# MASTER PLAN NARRATIVE for ST. XAVIER NATURE PRESERVE

Richard P. Rauso, ASLA  
Landscape Architect  
1025 Honey Locust Drive  
Jeannette, PA 15644  
412.370.4419  
RRausoLA@gmail.com

### Steering Committee Comments - Preliminary Master Plans:

### Steering Committee Comments - Draft Master Plans and Cost Estimates:

Preliminary Master Plan - Overall Site

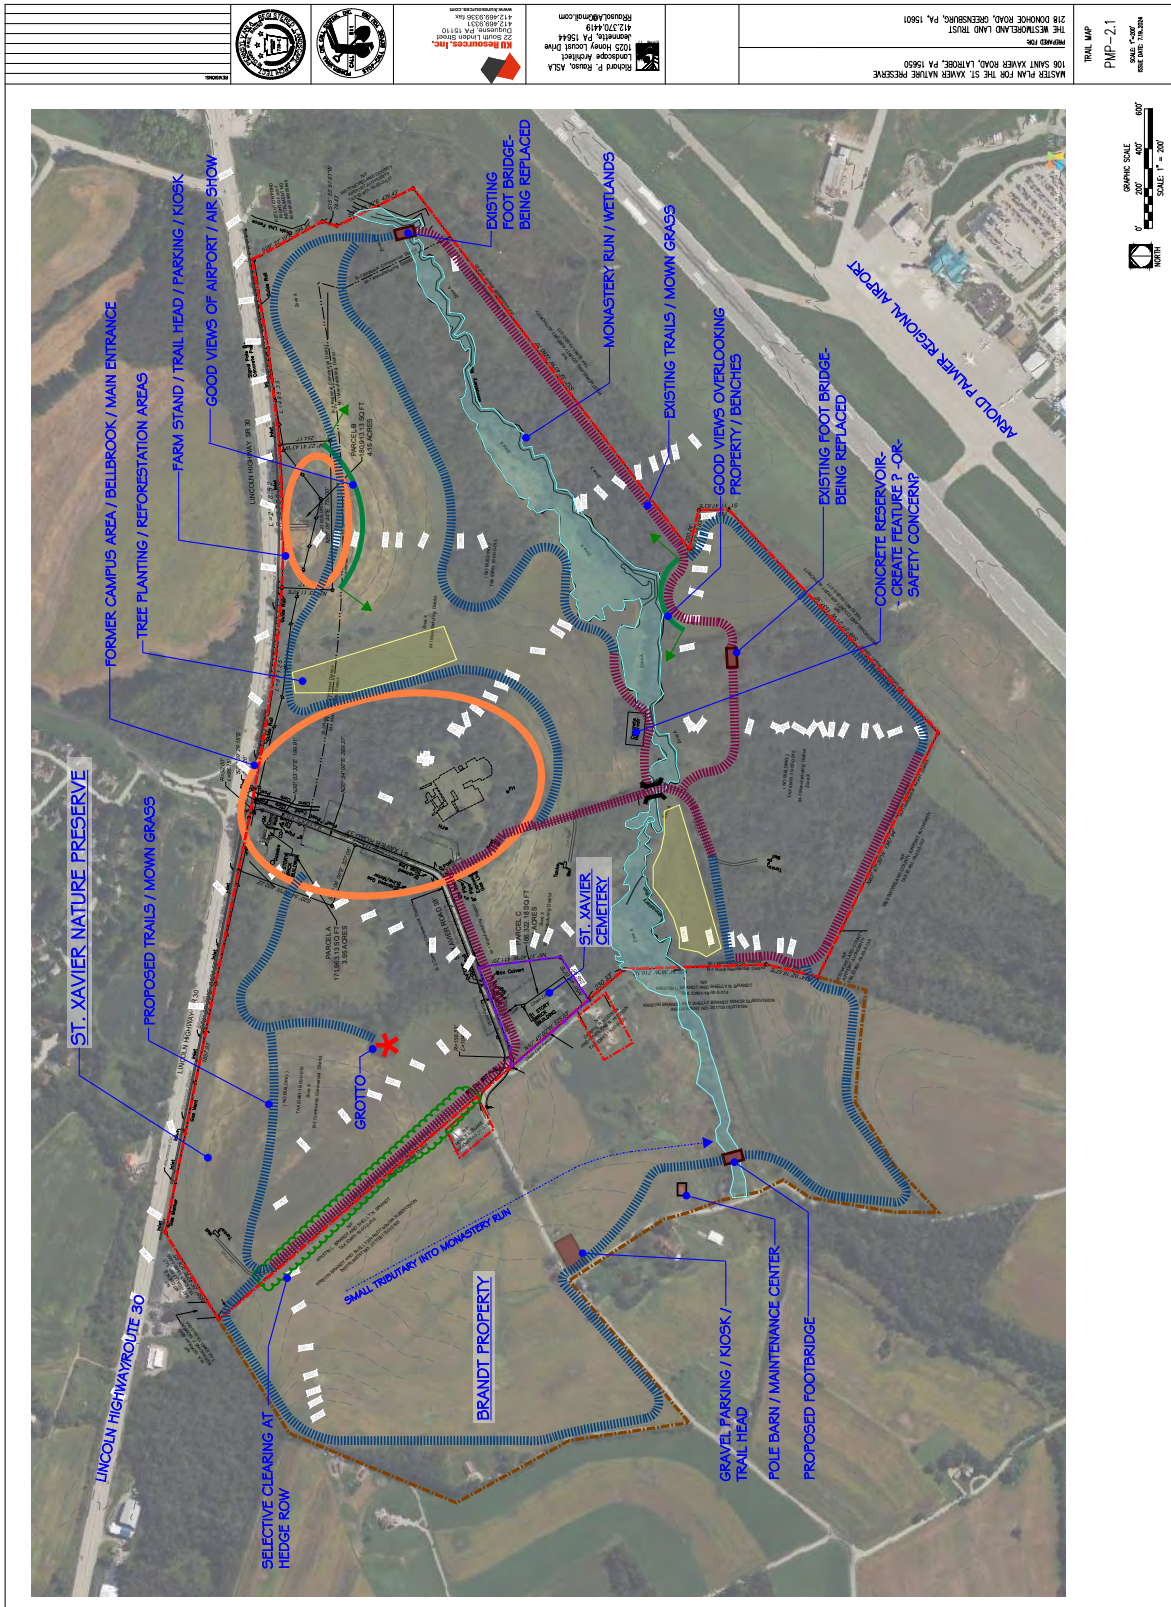
- More Pavilions.
- Eliminate the individual tent spaces on the farmstand drawing, and instead just designate those two rows as farm stand areas.
- Can remove replacement of (1) footbridge thanks to Brandon & the hunter volunteers.

- Option of stabilized turf for all parking lots (crushed stone for ADA spots).
- Option of crushed stone for ADA Walks to Pavilion & Restroom.
- Eliminate orchard

- Add option for crushed stone walkway through Grove
- Remove rehab of shuffleboard court
- Eliminate trash receptacles
- Eliminate repaving of tennis court

- Eliminate costs relating to pickleball
- Eliminate word "Airshow" from loop
- Show 2 pavilions in cost estimates; eliminate 3rd pavilion from plans.
- Question 25 mph signs (at WLT cost/discretion/responsibility) - St. Xavier Road is a township road.

- Remove dumpster pad from farm stand plans
- For Farmstand plans move Port-a-John pad to spot near former location, near concrete paved accessible parking

- Remove "airshow" from "mown grass path airshow loop"
- At St. Xavier / Route 30 intersection, the embankment would also have to be cut back to improve sight distance (would lose several trees). Asked during meeting - can the additional real estate available from the old entrance drive be used to widen to shift St. Xavier Road?

- Possible bench locations include: in the Grove, near the Grotto, on the loop trail below the farm stand, from an overlook position just above the CREP field on the trail along the field edge below the Academy building's footprint, at the "good view" location on the trail on the south side of Monastery Run.

- Like many elements of the Plan, including closing off the separate entrance and using the residual entrance drive for bus parking. I like the parking locations, but we may want to adjust their footprints. I like the ADA walk from the main parking area to Bellbrook, the street crossing from the main parking area to the Grove, and retaining walkways through the Grove.

- Not a fan of the planted orchard (could plant paw paws in understory openings in the scrappy woods below the campus area once the unwanted invasive ailanthus is cleared out).

- Not a fan of replacing the concrete walks through the Grove - would favor reworking what is there, and only spot-replacing where needed.
- Not a fan of converting the old loop drive to grass, would prefer to just leave it as is, for our utility use.

- Should there be a pavilion, soon or in the future? If so, should it have electricity, water, restrooms?
- Would like to leave the old shuffleboard court and the paved footprint of the old tennis court. We could keep shuffleboard supplies in the house for sign-out, and the old tennis

court would work for an augmented reality site using the charming old photo of it that we have.

- Keep the existing alignment of the paved paths through the grove, and not creating the new configuration and bench/landscaping surround for the old circular beds. Those beds could nonetheless serve as possible sites for sculpture - just no need for the paving, formal layout with benches and grid of walkways around them.

- Like the southern street crossing and the path to the Grotto but am not a fan of planted trees along the path, and question whether that path should be accessible.

- Like the idea of marking the location of the old entrance to the Academy buildings with a flush monument, but do not favor marking the entire perimeter. That seems too much; it would not bring enough value or interest to justify establishing or maintaining it. Not a fan of the idea of donor bricks - it would be so much easier to honor donors in a list in Bellbrook, and we wouldn't be challenged by wear, disintegration, or maintenance of bricks. Not a fan of a constructed archway - prefer to leave the landscape uncluttered, with a flowering meadow planted in the field of the old buildings. We can use augmented reality to give nice views of the old buildings.

- Give careful thought, and obtain Jack's, Brandon's and John's and others' input about layout of trails through or around the fields. 100' minimum setback from roadways is required for the Brandt trails. Long stretches of straight lines may not be desirable for visual interest. The NW neighbor of Brandt would likely appreciate more buffering. We may want a trail from the far/gas well road entrance opposite the cemetery to skirt the woods. to the right to the opening into that side of the woods for the grotto. The alignment of the trail crossing the western field of St. Xavier could be adjusted to more closely follow contours.

- Eliminate the parking area at the intersection of St. Xavier and Earhart Roads.
- Have an information kiosk by the main parking area.
- A potential use for the old concrete reservoir could be as a demonstration of the progression of natural restoration (even with the concrete base). It could become an interesting interpretive exhibit; we'd only need to confirm its safety from falls and for egress?

- Think about locations and composition of nice, substantial St. Xavier Nature Preserve signs: 1) One at entrance location of old St. Xavier sign, (2) One at old location of Firestone sign in western meadow. (3) One at old location of dumpster along St. Xavier Road.

- Think about more modest signs or another way to mark the western and eastern edges of the property along Route 30.
- Think about Route 30 wayfinding road signs to the Preserve - one sign heading east, and one heading west.

Draft Master Plan - Farmstand Area

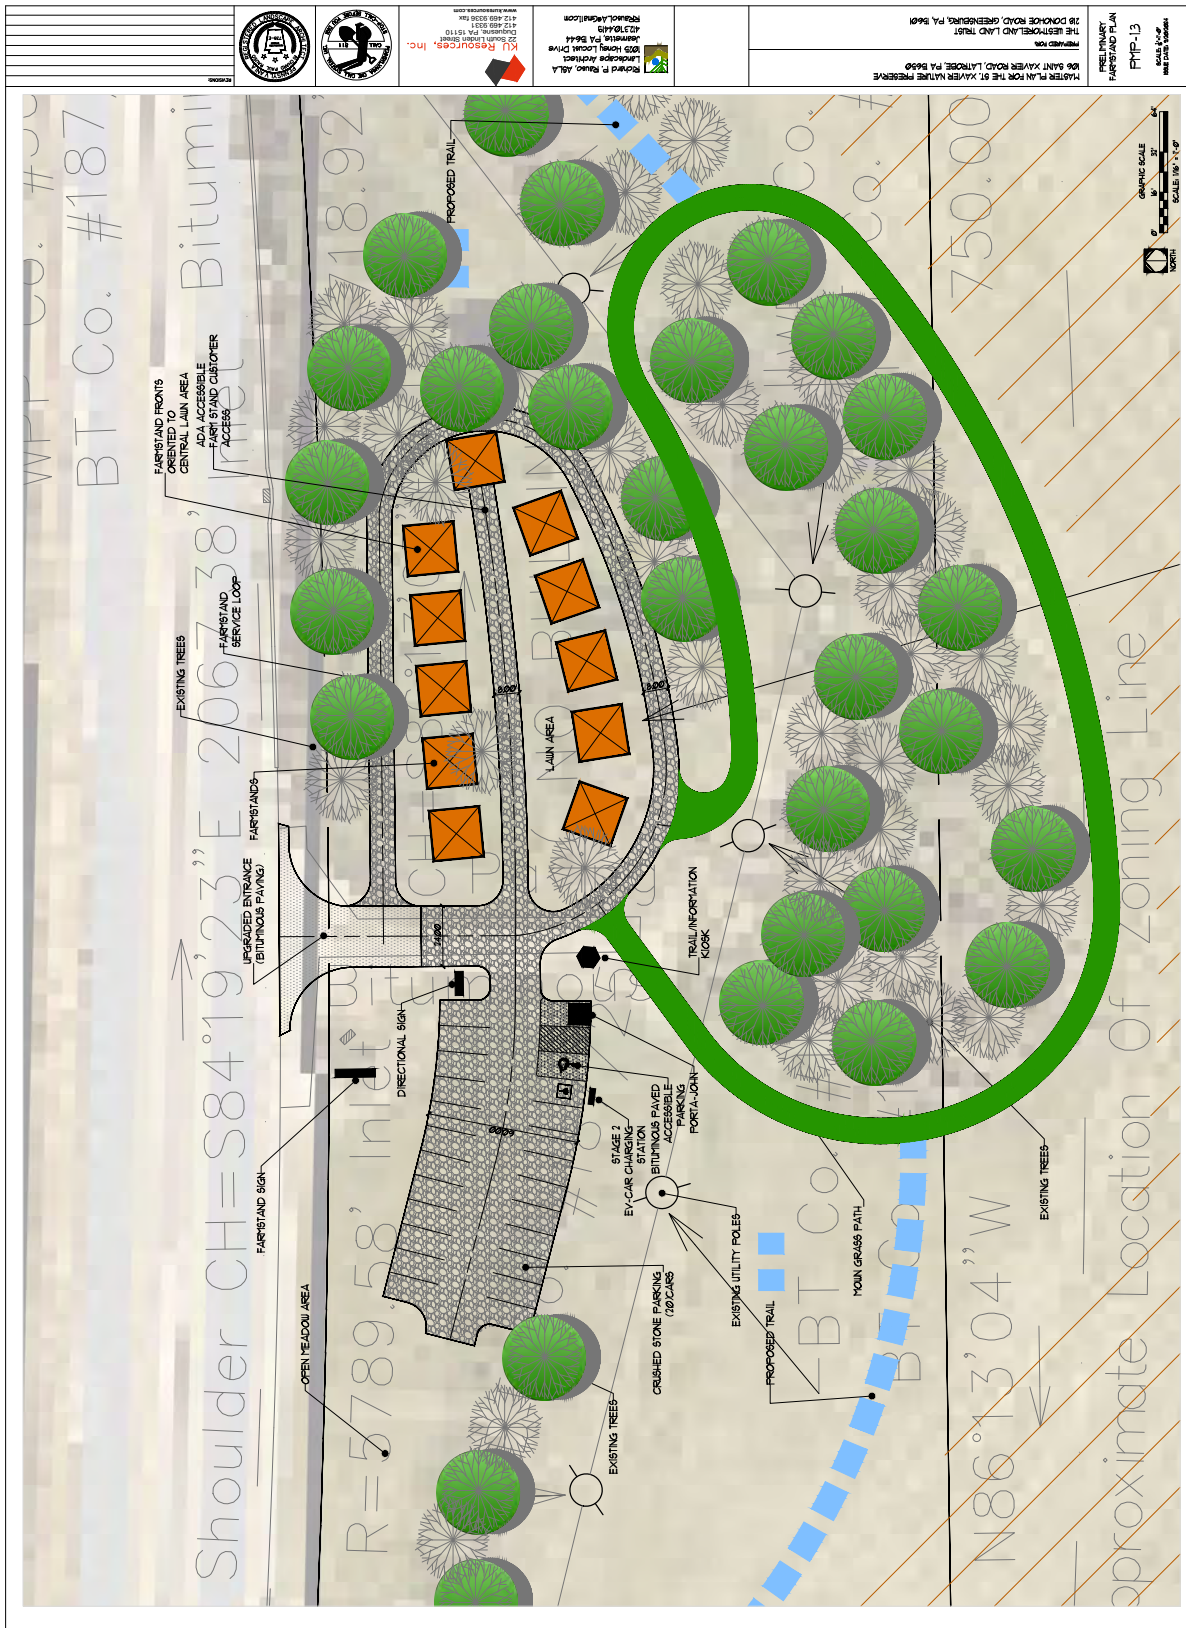
- Remove replacement of (1) footbridge thanks to Brandon and the hunter volunteers.
- Show option of stabilized turf for all parking lots (crushed stone for ADA spots).

- Show option of crushed stone for ADA Walks to Pavilion & Restroom.
- Eliminate orchard.
- Add option for crushed stone walkway through the Grove.
- Remove rehab of shuffleboard court

- Eliminate trash receptacles
- Eliminate repaving of tennis court, eliminate costs relating to pickleball
- Eliminate word "Airshow" from loop
- Show 2 pavilions in cost estimates, eliminate 3rd pavilion from plans.

- Provide 100' buffer from St. Xavier and Earhart Road for proposed trails on Brandt Property.
- Remove proposed trail thru wooded area.
- To allow for flexibility for proposed trail locations, indicate proposed trails as 'Possible Trail Alignment.

- Move Directory Sign along St. Xavier Road.
- Remove fence note from concrete reservoir.
- Locate Materials Storage area to area south of existing maintenance barn.

- Farm Stand Plan: Relocate benches from mowed grass path to existing power line.
- Farm Stand Plan: Note as 'Potential' EV charging station.
- St. Theresa Grotto: Add note for repair drainage pipe under existing concrete walk.

- Completely remove bituminous paving and add topsoil/seed to former St. Xavier entry road.
